Explanation of Significant Difference for the Revision 1 Record of Decision Remedial Alternative Selection for the Wetland Area at Dunbarton Bay in Support of Steel Creek Integrator Operable Unit (U)

SRNS-RP-2022-00982

Revision 1

April 2023

Figure 4. Expanded Area Subject to Land Use Controls

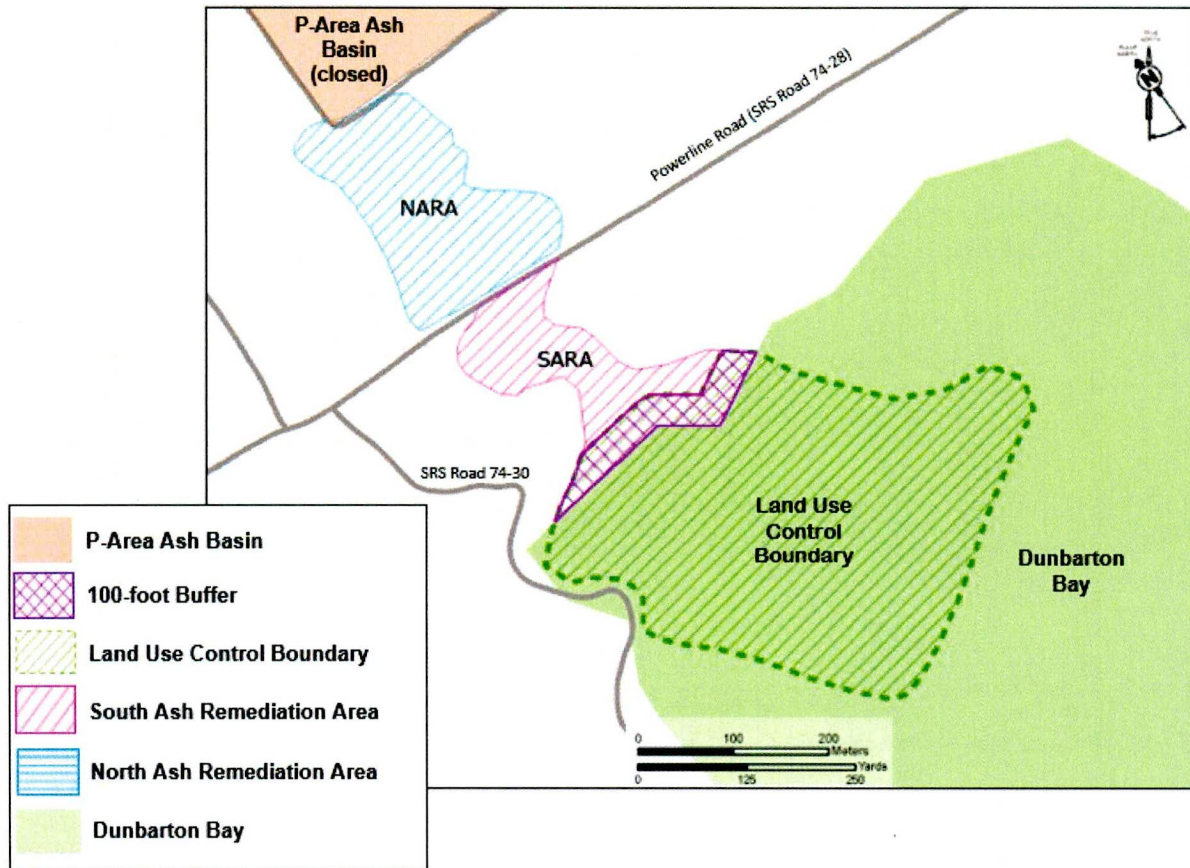
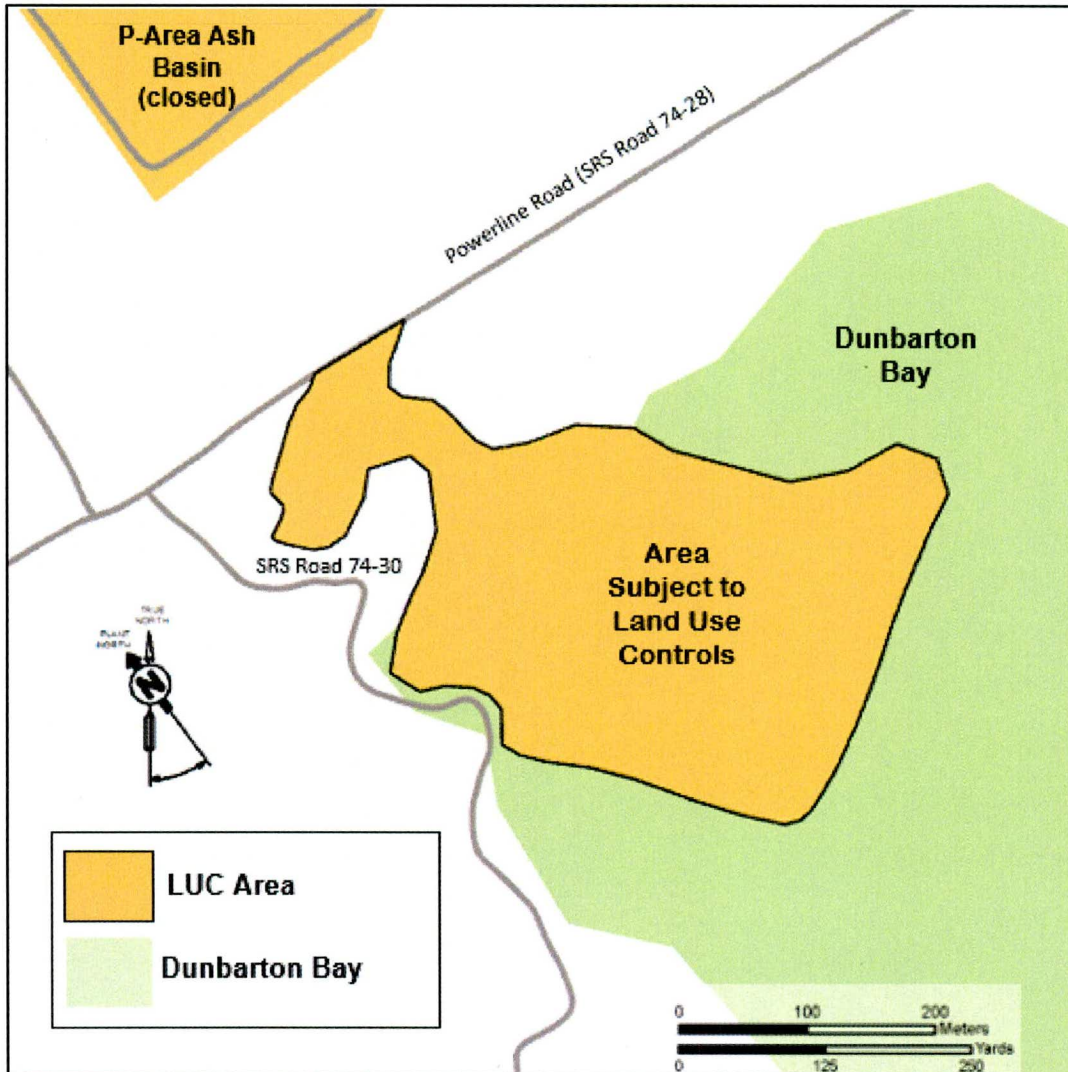
The remedial action addressed in this ESD requires an expanded LUC boundary for the WADB beyond the initial LUC area established for Dunbarton Bay. The expanded LUCs are being implemented to include the ash deposits remaining in the SARA and the additional ash discovered outside of the boundary of the SARA

The ROD for the WADB was issued June 20, 2018 (SRNS 2018a). The significant difference described in this ESD is to expand the LUC boundary to include the SARA and additional ash to the east of the SARA. Expansion of the LUC boundary will be protective of human health and the environment without additional excavation and disposal of the ash. The additional ash is located between Powerline Road and Dunbarton Bay (Figure 3).

The actions described herein are documenting an expanded LUC boundary for the WADB from Powerline Road to the 30-m (100-ft) buffer along the northern edge of Dunbarton Bay. The LUC boundary maintains the previously designated LUC area within the 30-m (100-ft) buffer and within Dunbarton Bay (Figure 3). The entirety of the expanded LUC boundary consists of ~16 ha (~39 ac) (Figure 4). The expanded LUCs are estimated to cost approximately \$50,000. It is estimated that pursuing continued excavation and offsite disposal of the SARA and additional ash would cost approximately \$5.8 Million due to the saturated field conditions along with an escalation factor from 2019 to 2023 dollars. This additional cost would result in a total remedial cost for the WADB that exceeds the ROD estimate.

The ROD for the WADB (SRNS 2018a) employed LUCs for 10 ha (25 ac) since the entire volume of waste was not to be excavated and some material would be left in place. The initial LUC boundary is shown in Figure 2. The purpose of this ESD is to document expanded LUCs that include the SARA, the additional ash discovered outside of the SARA, as well as the initial LUC boundary protective of and within the Dunbarton Bay.

Figure 3. Location of Additional Ash, Existing Sign Locations, and Existing Land Use Control Boundary

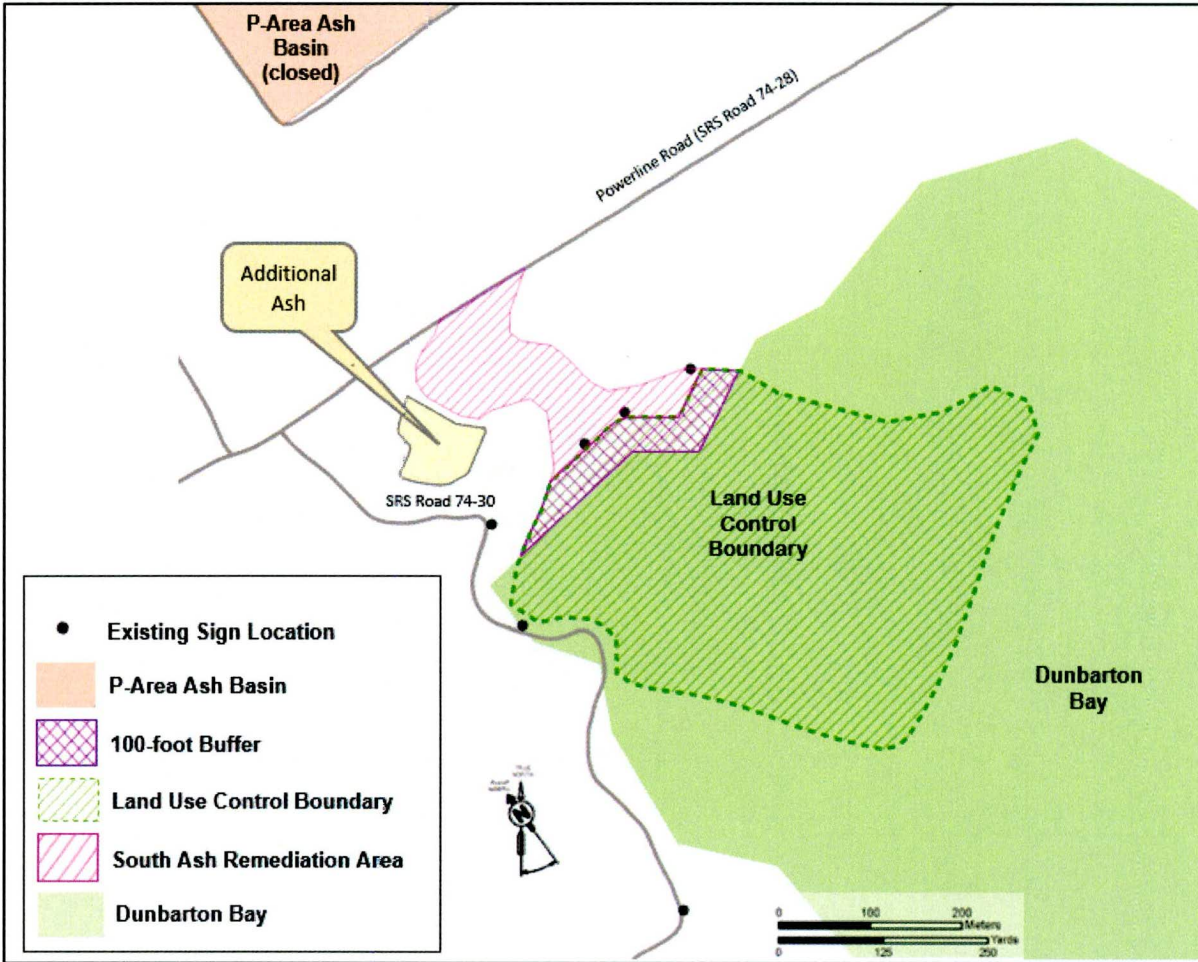
The design for the implementation of the selected remedy for the WADB OU consisted of two distinct areas of ash excavation: the North Ash Remediation Area (NARA) and the South Ash Remediation Area (SARA) (Figure 2). The volume of ash removed from the NARA and SARA is presented in the Post Construction Report (SRNS 2020). The remedial action for the NARA is complete and supports unrestricted land use. Excavation activities in the SARA were intended to be executed beginning with the section adjacent to the buffer area. However, following initial excavation activities in the SARA, a status meeting was held in June 2019 with the Core Team (i.e., USDOE, USEPA, and SCDHEC) to discuss field conditions due to the discovery of the presence of shallow perched water and additional ash discovered outside of the limits of the SARA ash boundary (Figure 3). The area of additional ash was
